SUBJECT: Meeting Notice and Agenda

**SUBDIVISION:** Pickerington High School North & Lakeview Junior High School  
– Replat of Hickory Lakes Drive & Reserve “A”

**PROPOSED REZONING:** PD – Planned Residential District.

VIOLET TOWNSHIP, FAIRFIELD COUNTY, OHIO  
PRELIMINARY DEVELOPMENT PLAN  
FOR  
**COURTYARDS AT VIOLET MEADOWS**  
EXISTING CONDITIONS PLAN

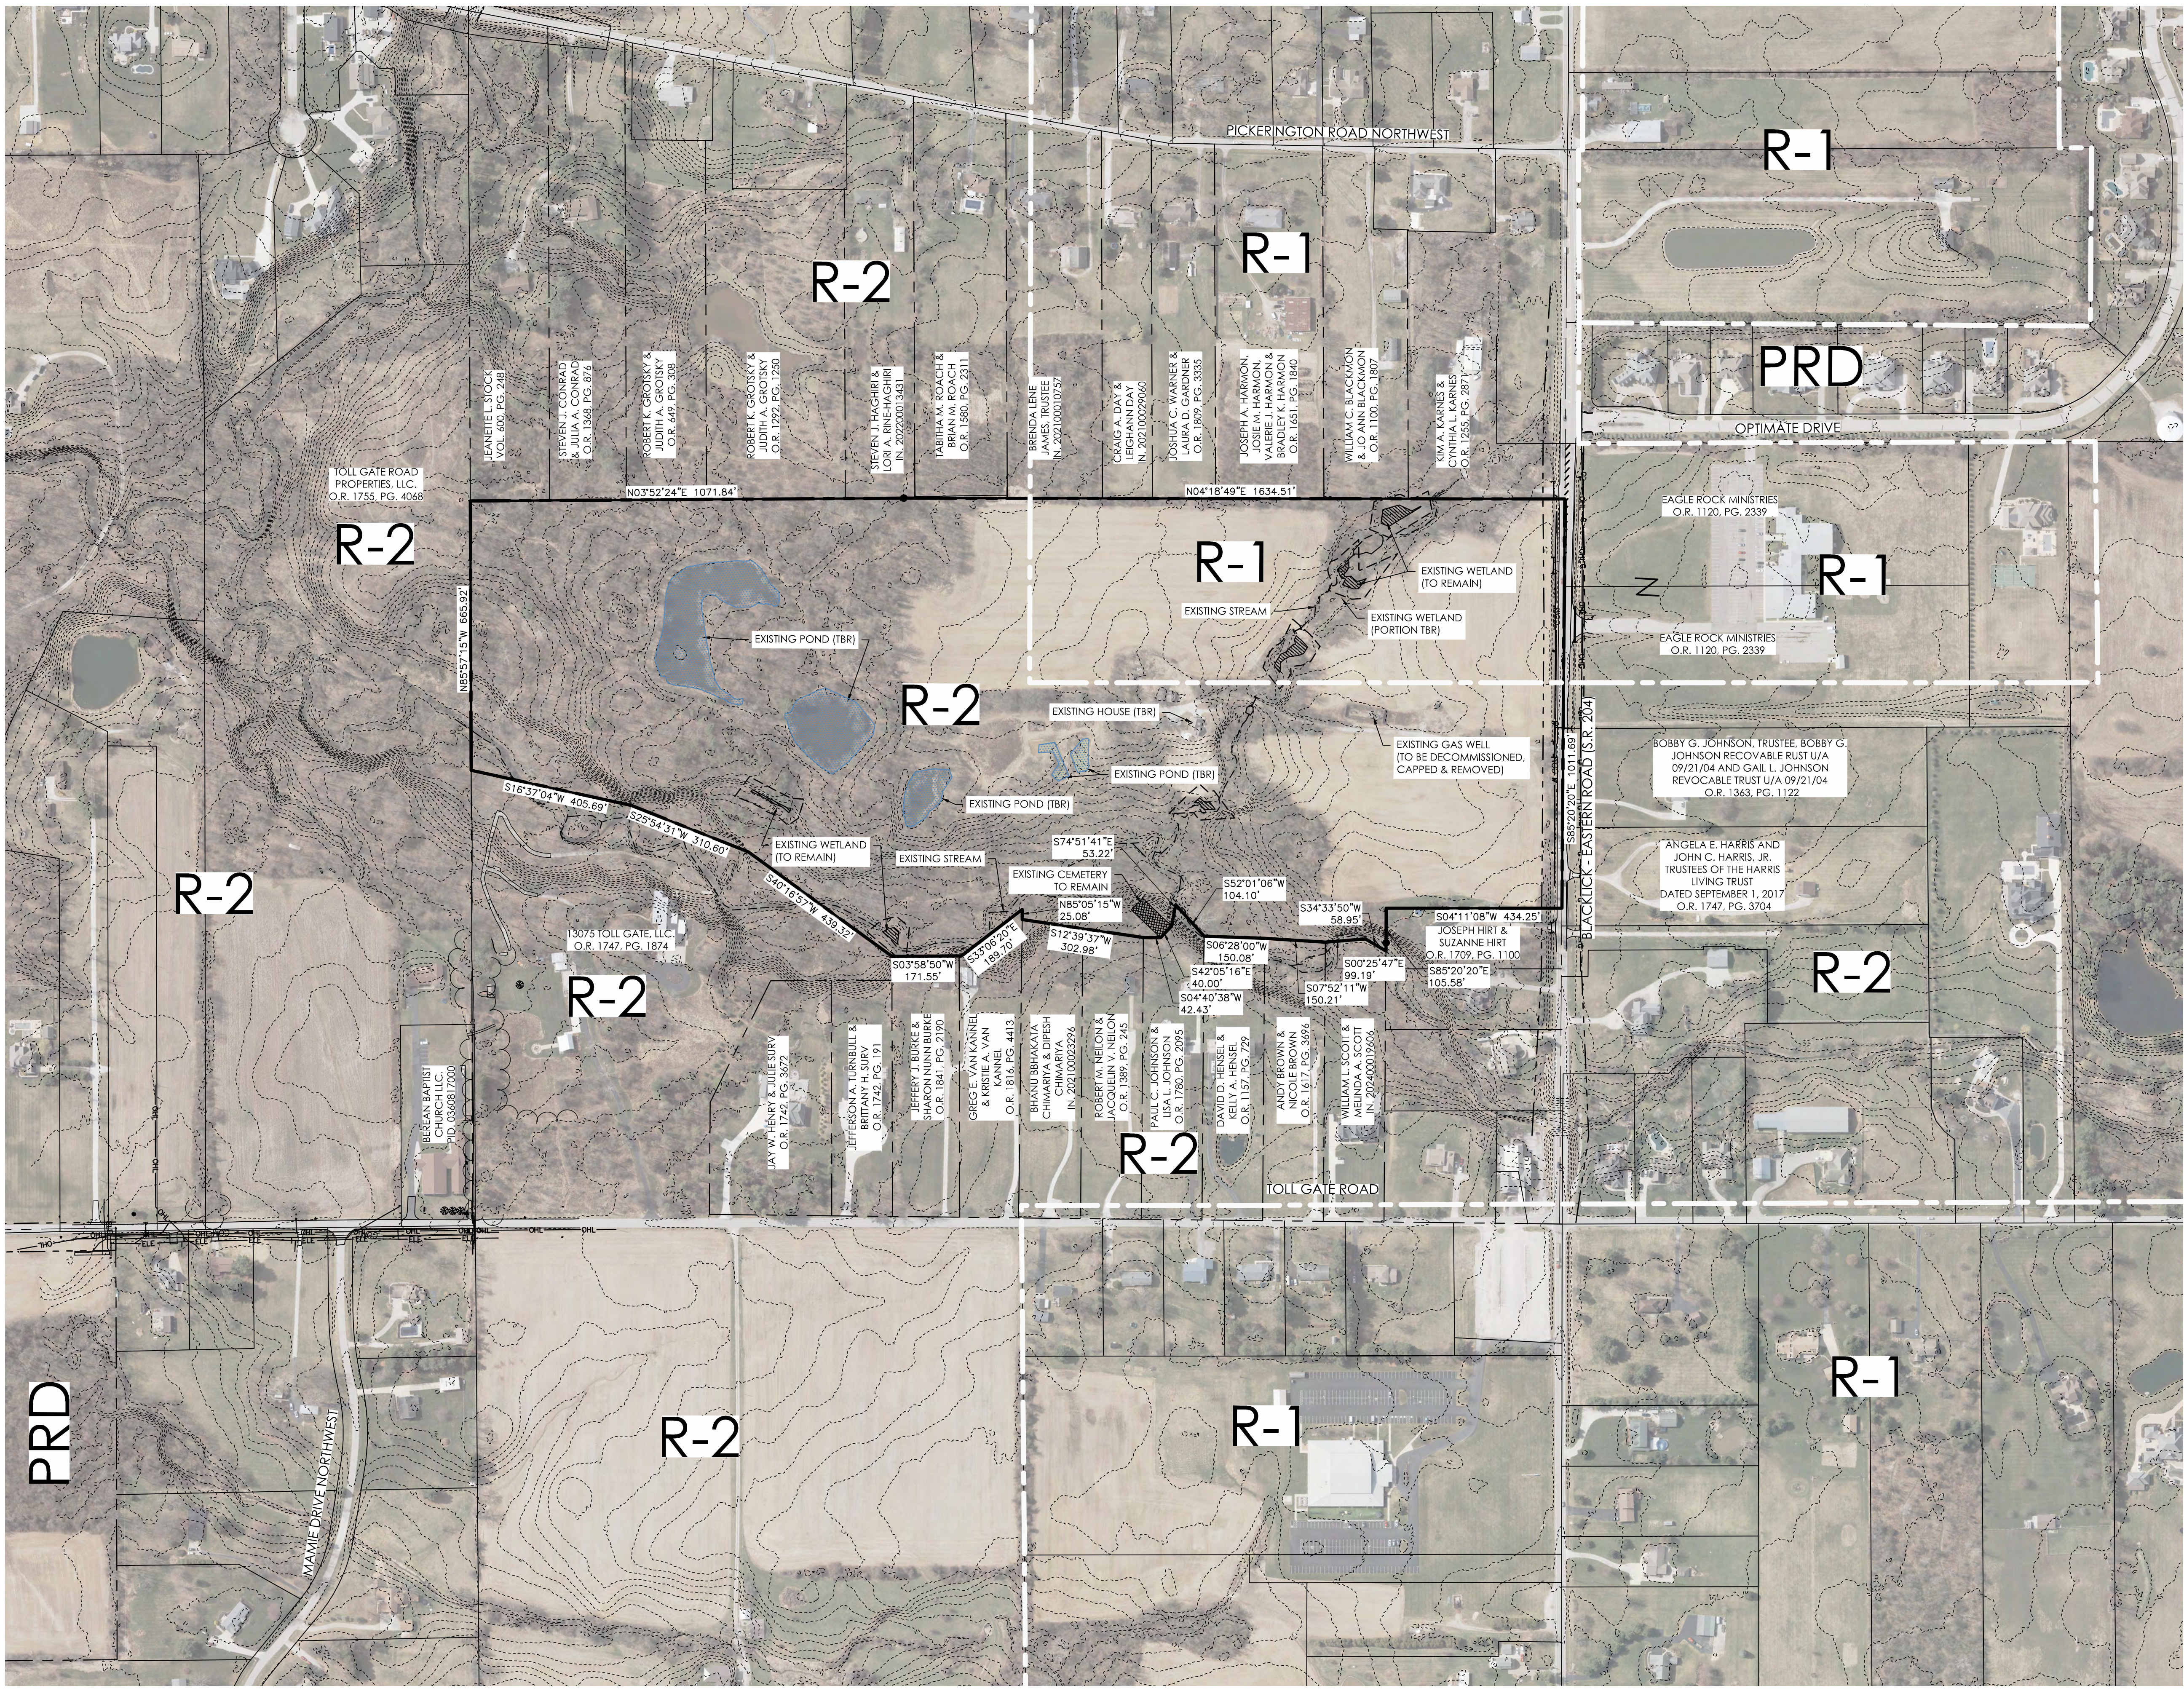
1. An environmental report will need to be completed to identify wetlands, streams, or other environmental areas. The plans indicate that there are wetlands and streams located on the site. Some are shown to be staying while others are showing to be removed.

3. There were questions if there were any required setbacks for gas/oil well and storage tanks on the property, while acknowledging that the plans indicated that they will be decommissioned, capped, and removed.

5. There was a question about ownership and maintenance of the existing cemetery on site.

1. An environmental report will need to be completed to identify wetlands, streams, or other environmental areas. The plans indicate that there are wetlands and streams located on the site. Some are shown to be staying while others are showing to be removed.

3. There is an existing gas/oil well and storage tanks located on the property. Are there any required setbacks associated with the well or storage tanks? The plans indicated that it will be decommissioned, capped, and removed.

5. There is an existing cemetery shown on the plans. Who maintains the cemetery?
